A6097-Kirk Hill East Bridgford

**Road Safety Audit
Stage 1 - Completion of Preliminary Design**

SA2404A
Nov 2020

Stage 1 Road Safety Audit

Location: Ref 3.4 Kirk Hill Public Footpath.

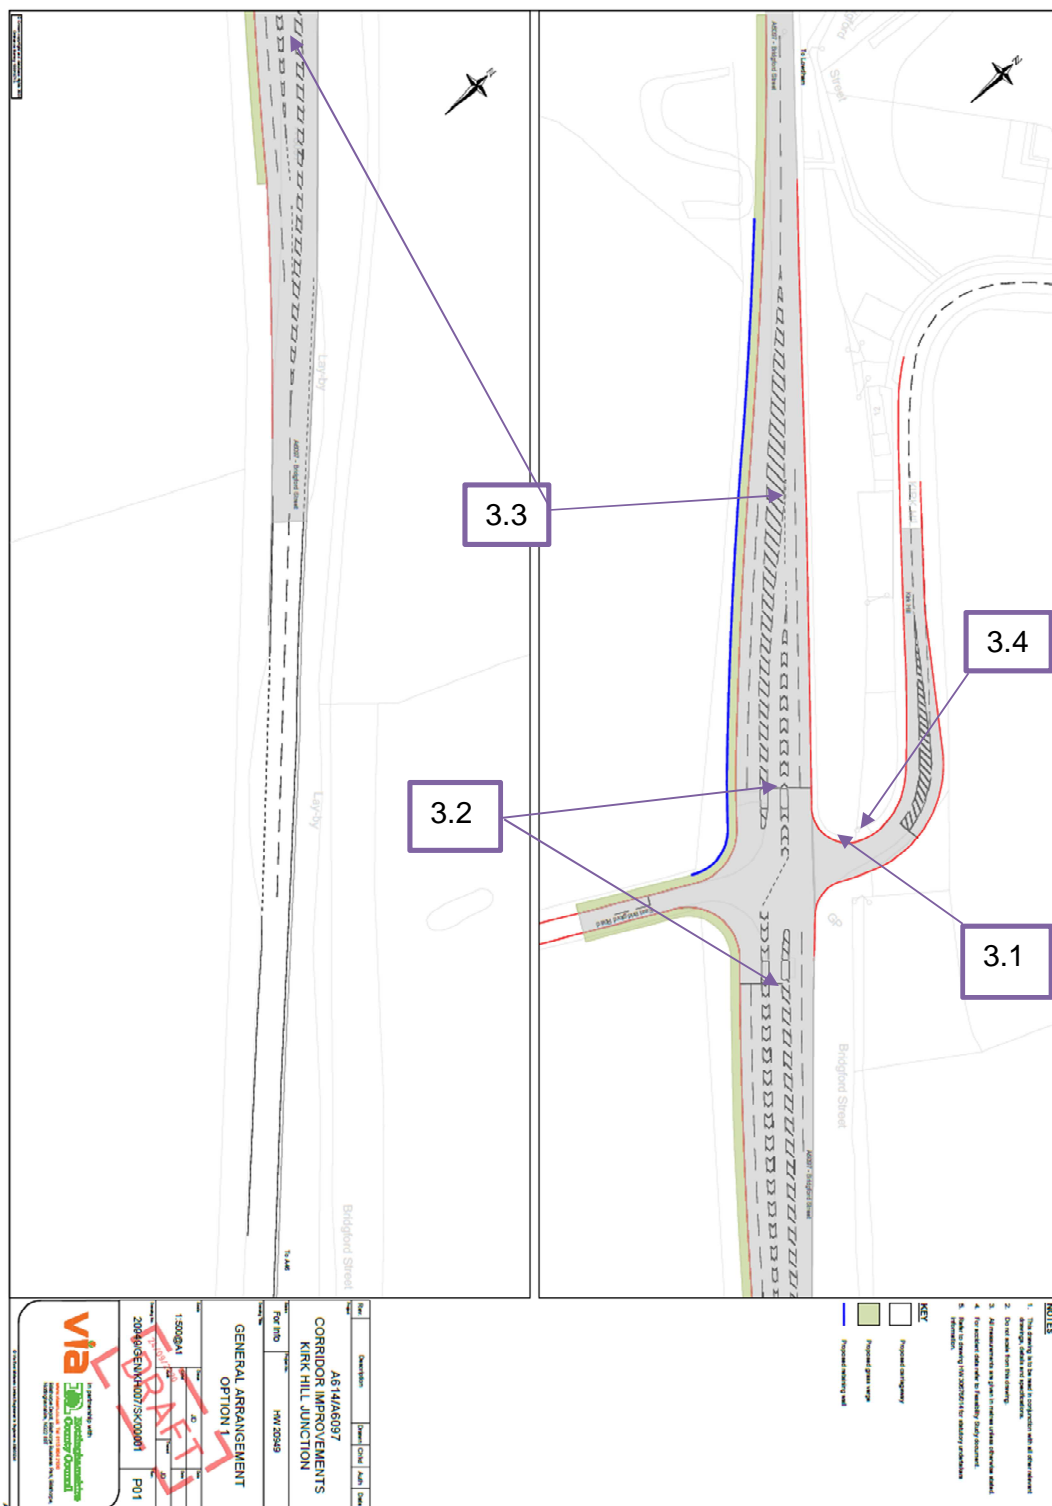
Summary: Pedestrians injured in collision with vehicles at junction.

There is an existing footway on the north side of the A6097 from Gunthorpe to the signal junction and then a public footpath that connects to the A46 junction. The footpath looks well used. Pedestrians have no view of a left turning vehicle from the A6097, which could result in pedestrians stepping into the path of vehicles, with the potential for serious injuries to arise from any collisions that occur.

Incorporate a push button- controlled crossing for pedestrians across this arm and improve inter-visibility between vehicles and pedestrians by removing vegetation on this radius (see problem 3.1)
